MIL-S-70471(AR)
AMENDMENT 1
25 June 1990

MILITARY SPECIFICATION

SAW, M249 BLANK AMMUNITION MAGAZINE ASSEMBLY
AND FEEDSTRAP

FIGURE 1

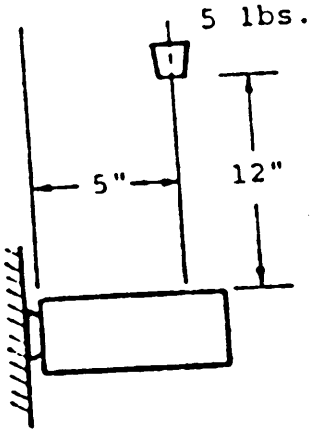
4.7.3 Add: "The test fixture (see Figure 1) shall use a weapon mount representing the minimum material (loosest) condition of drawing 9348215 Feed Box Support.".

Add: Figures 1 and 2 as follows:

FIGURE 2

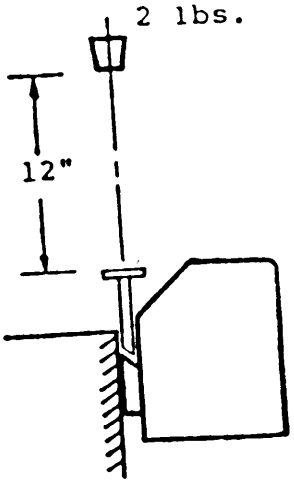
4.7.2 Add: "The test fixture (see Figure 2) shall use a weapon mount representing the minimum material (loosest) condition of drawing 9348215 Feed Box Support.".
